UNITED STATES TESTING COMPANY'S
Response to the Bechtel Report

"Review of U. S. Testing Field
and Laboratory Construction
Test Data on Soils Uses as Fill"

Midland Units 1 & 2
Job No. 7220

REVIEW OF U.S. TESTING
FIELD AND LABORATORY CONSTRUCTION
TEST DATA ON SOILS USED AS FILL

FIGURE 1

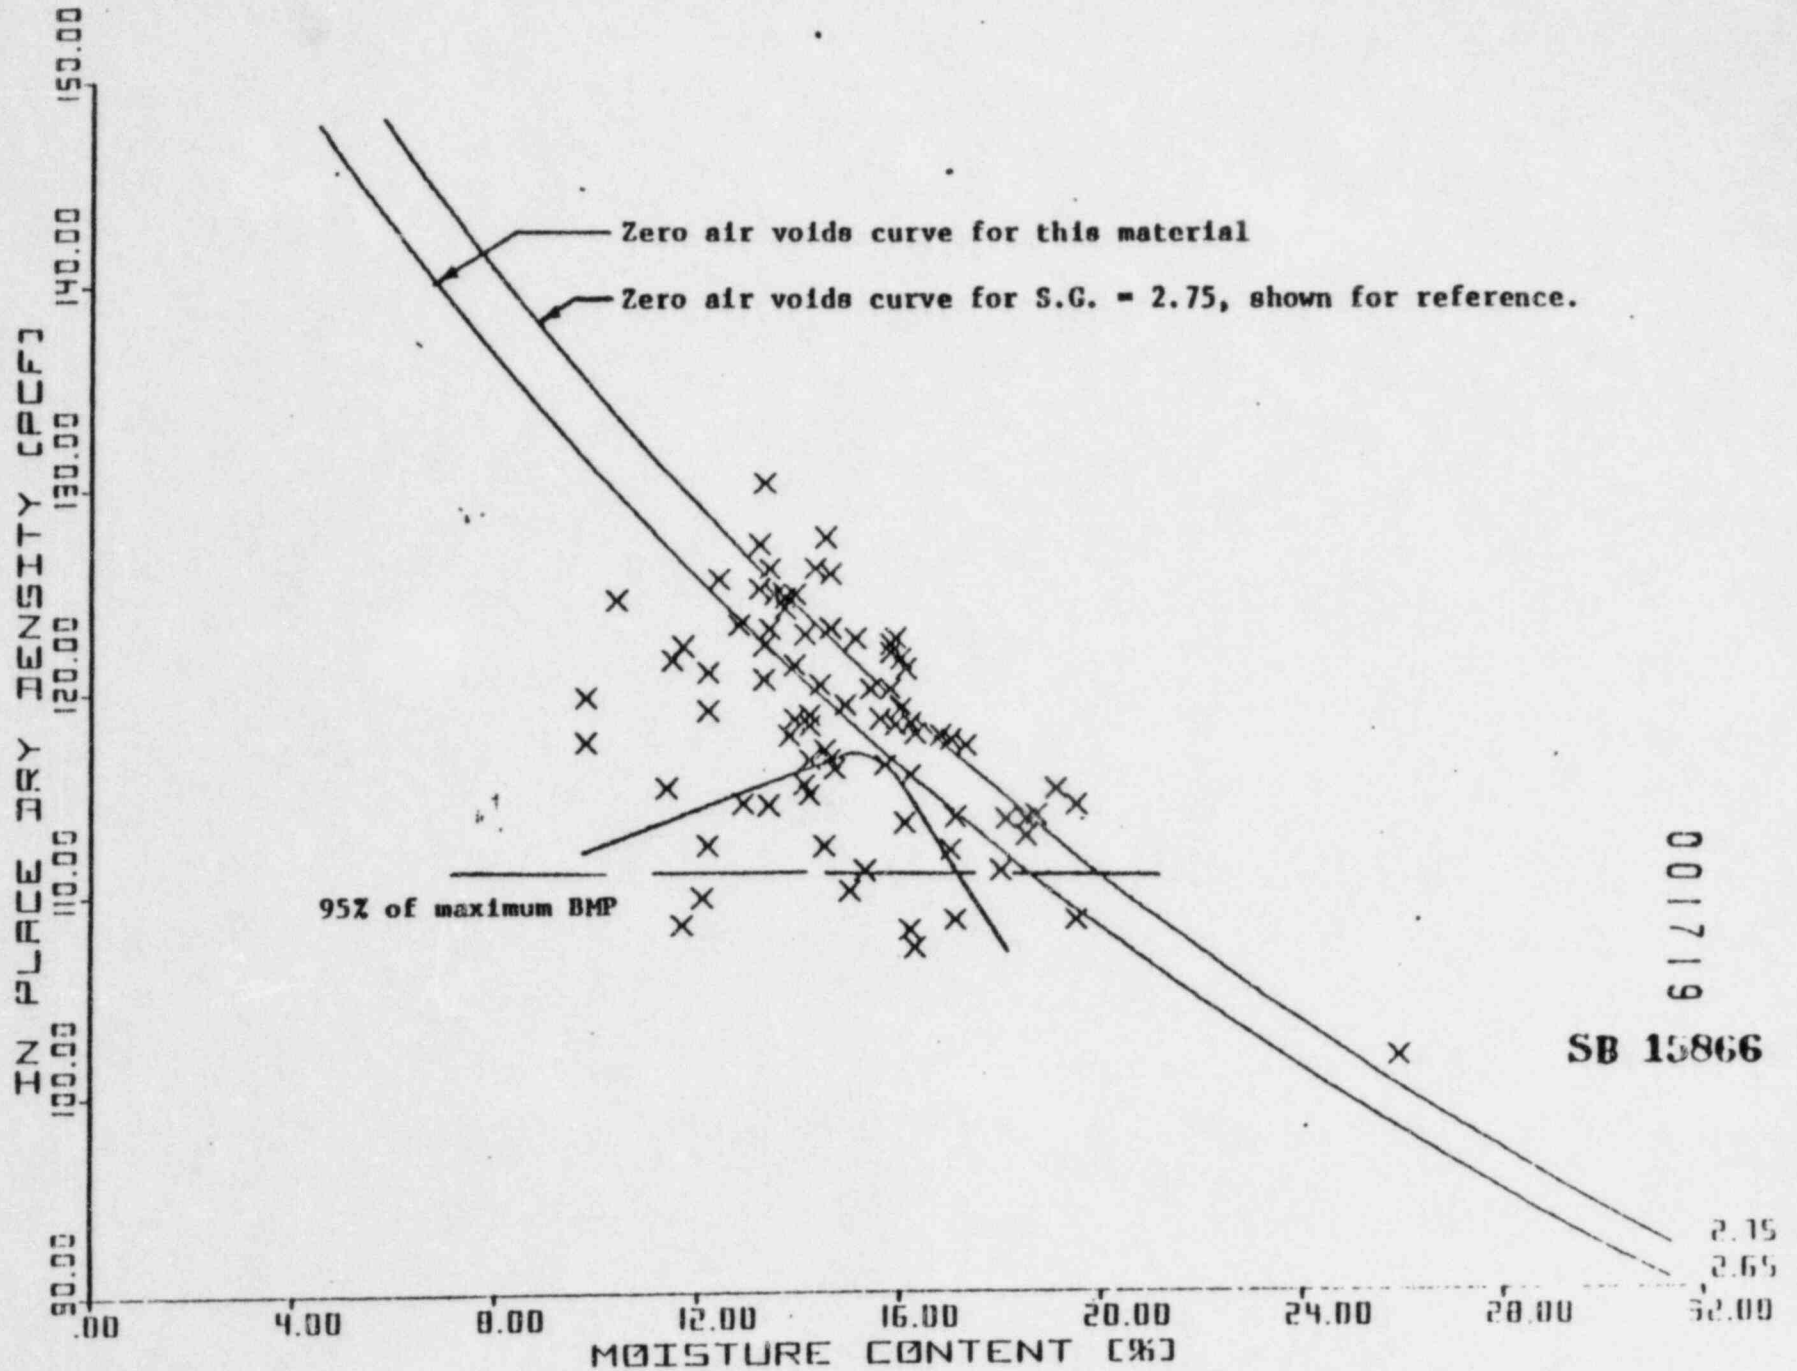
band of specific gravity values represented in the Bechtel report figure 1 results in a 49 percent reduction of theoretically impossible results. The remainder of these test points falling above zero-voids line will be discussed in Section 6. However, specific gravity values from 2.57 to 2.82 for soil fractions are documented for material on this project.

Soils cannot be more than 100 percent saturated; therefore, all field density test data points, when plotted as dry density versus moisture content, must be below the zero air voids curve as defined by the specific gravity of the material. Specifications do not require examination of the zero air voids curve, but it is considered common practice relative to compaction plots. There are numerous cases in the U. S. Testing Company data where points plot above the zero air voids curve. Figure 1 attached shows a typical laboratory compaction test curve with field test results plotted on it. Many of the field test results are to determine percent compaction plot above the zero air voids curve. Provided the specific gravity is correct this is not possible so that all such points must represent erroneous data.

The fact that a large number of test results plot above the zero air voids curve tends to make all test results questionable.

Also, referring to Figure 1 it would appear that soil density varied widely. Specifications called for compactive effort results as defined by ASTM D 1557 which is 56,255 ft-lb/ft³ energy. This was modified to a laboratory test compactive effort of about 20,000 ft-lb/ft³ energy, often referred to as Bechtel Modified Proctor (BMP). Laboratory compaction test curves should be related to the same effort as that called for in the field for use in comparing with field density tests to determine percent compaction. According to plots of field data shown on Figure 1, density varied from about 108 lb/ft³ to about 130 lb/ft³. It is doubtful that the soil classification or other properties would be similar for such a wide variation in density. It is noted that 100 percent of modified Proctor (ASTM D 1557) which is difficult to obtain, is rated at 56,255 ft-lb/ft³ energy. The curve plotted on Figure 1 is at about 20,000 ft-lb/ft³ energy. For comparative purposes it was determined by U. S. Testing in 1974 that 100 percent of specified effort (20,000 ft-lb/ft³) is approximately equal to 95 percent of the maximum density as determined by ASTM D 1557 (56,255 ft-lb/ft³) Reference Figure 8.

FIGURE 3

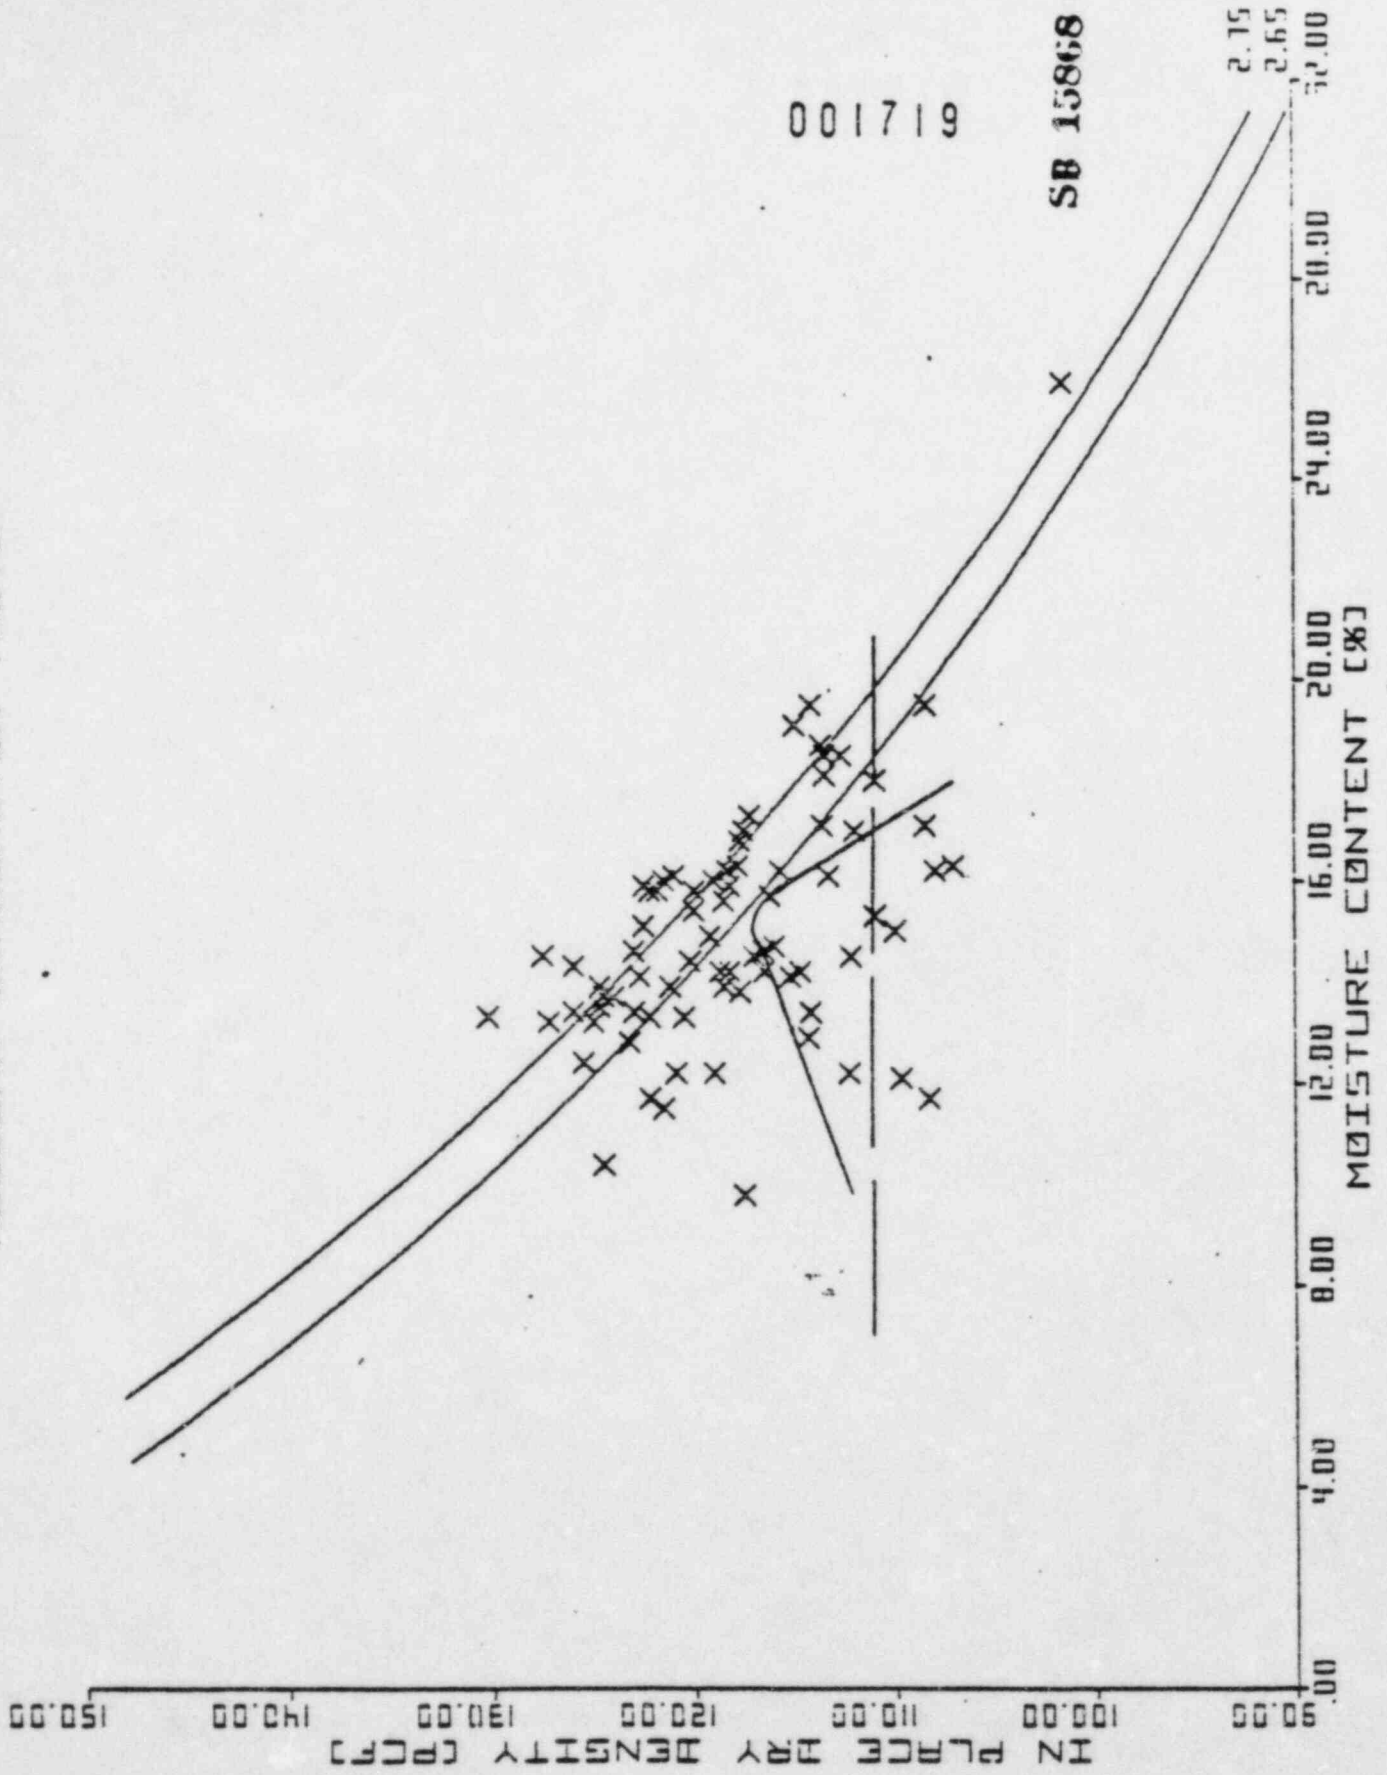
Plots of field data for compaction test BMP 278 are shown on Figures 1 through 6. The title of each figure gives the assumptions made in plotting data for the figure. In comparing figures 3 and 4 it is seen that a majority of field tests were made using the nuclear device. The two test results shown on Figure 4 for the sand cone method indicates one test result on each side of the zero air voids curve. The one falling above the zero air voids curve (shown on Figure 4) is designated by U. S. Testing Company as the only passing sand cone test (shown on Figure 6).

FIGURE 7: WINDOWS OF ACCEPTABILITY (A) BASED ON BMP
 SPECIFICATION (B) REGARDLESS OF EXACT WORDING OF
 SPECIFICATION

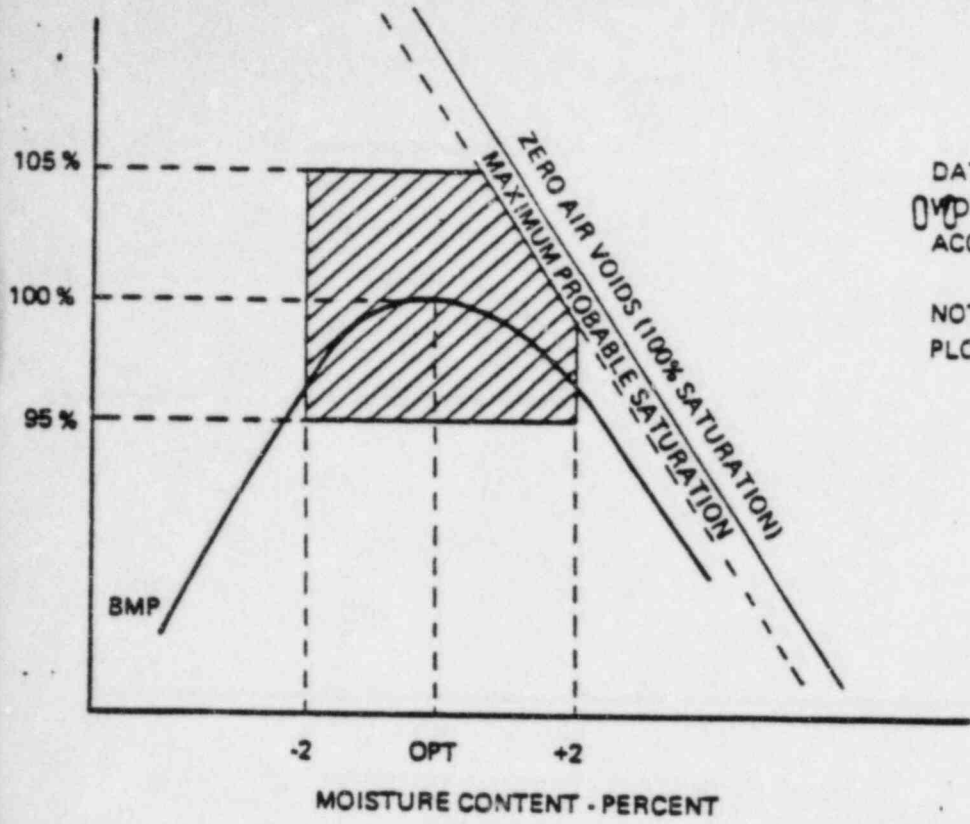
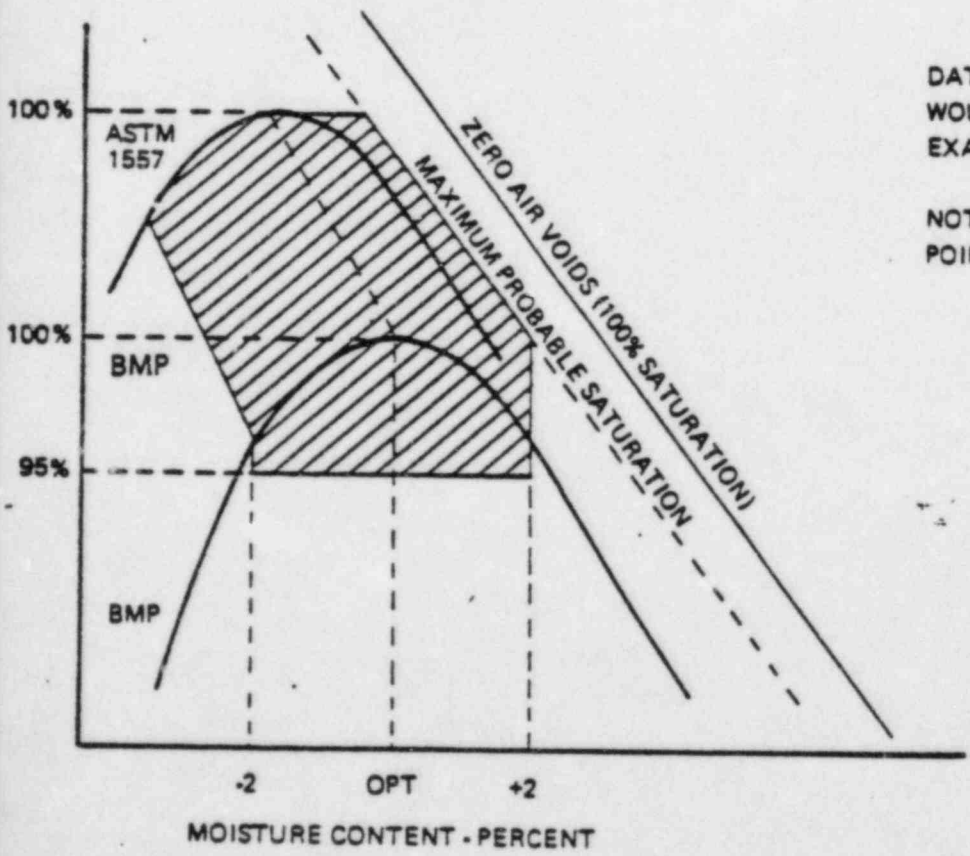
For a field test result to be valid as well as "Passing" it must fall within a well defined area on the plot containing the laboratory compaction curve. This area or window of acceptability is shown for a hypothetical compaction curve on Figure 7a that would meet requirements of Specification 7220-C-210. It is defined by horizontal lines at 95 percent and 105 percent of specified density, vertical lines through ± 2 percent of optimum moisture content, and a line parallel to the zero voids line indicating saturation about half way between the compaction curve and 100 percent saturation (zero air voids curve). The practical upper limit of 105 percent of specified density is not defined in the specifications. It was arbitrarily chosen as numbers greater than this give increasingly invalid comparisons between field test results and the specified laboratory compaction test curve. Therefore, if all data points fall within the defined window there would be no reason to assume that they are wrong. However, when many data points fall outside the designated area there is something wrong with the information and then all data points become suspect. A review of all data indicates that about 25 percent of the cohesive soil test results fall within this area.

Figure 7B shows an area where field test results would be acceptable, in theory even though not in strict accordance with the specifications. Figure 7B was arrived at by expanding Figure 7a to include test results up to a compactive effort related to ASTM D 1557 (56,255 ft-lb/ft³) which is considered to be a practical upper limit. About 40 percent of all cohesive soil test results would plot in this area.

FIGURE 9

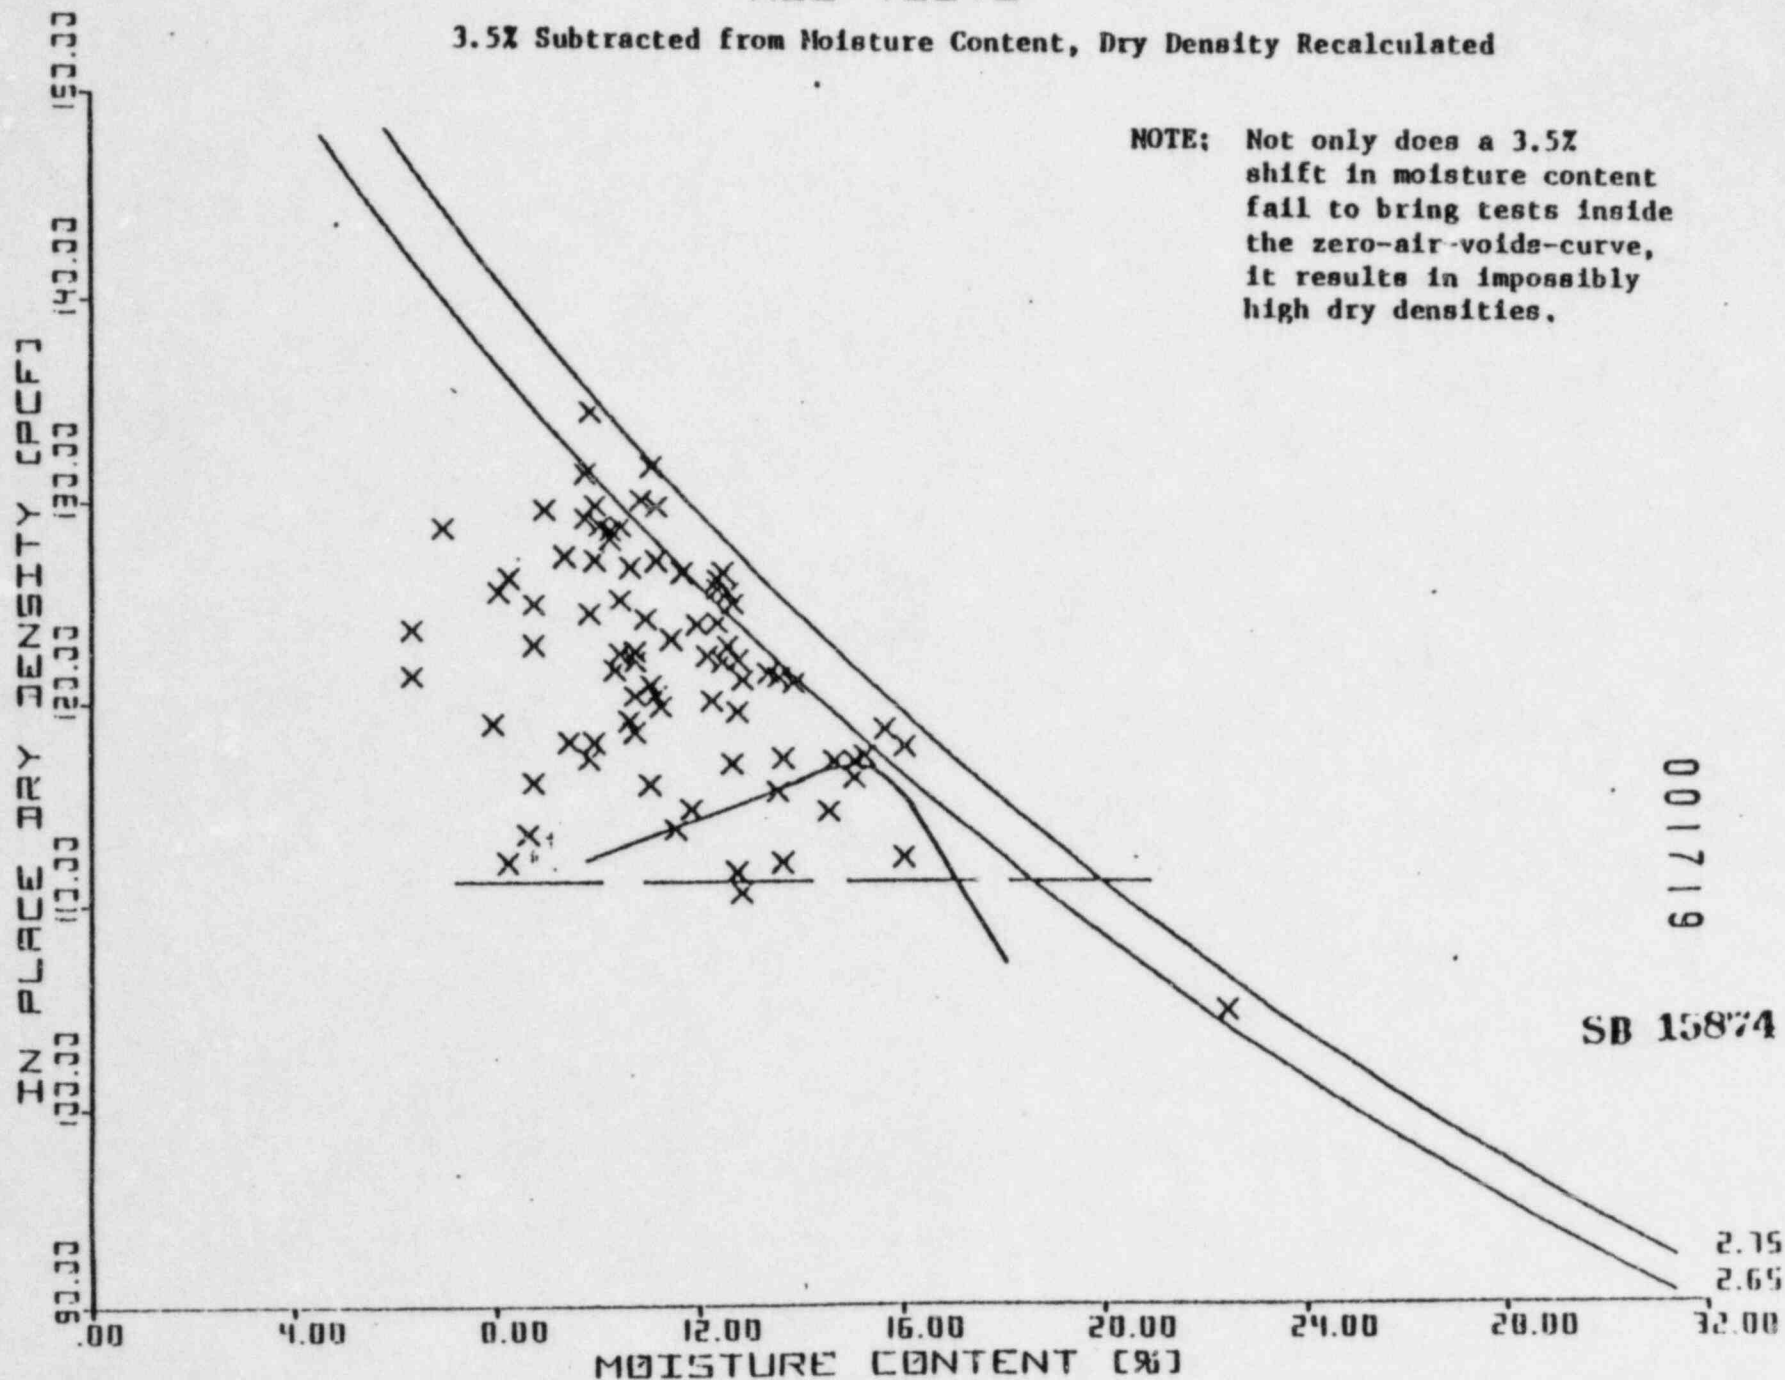
In a letter from U. S. Testing to Bechtel (dated May 30, 1974), the average deviation of the nuclear device from oven-dry moistures was +.12% for a set of 30 tests. However, the standard error of estimate is 1.8% for the data with the range of differences being from - 3.2% to +3.9%. Thus, accuracy of the nuclear device is questionable, and could translate into errors of about ± 4 pcf in the dry density calculation. (It should be noted that errors in the moisture content tend to shift the position of test results on a moisture density plot approximately parallel to the zero air voids curve, assuming the in-place wet density is correct, and thus do not explain the large number of points which plot outside the zero air voids. Compare Figures 1 and 9).

NOTE: Not only does a 3.5% shift in moisture content fail to bring tests inside the zero-air-voids-curve, it results in impossibly high dry densities.

Contrary to the assumption regarding figure 9 with its "impossibly high dry densities" current test data closely resembles this graphical representation.
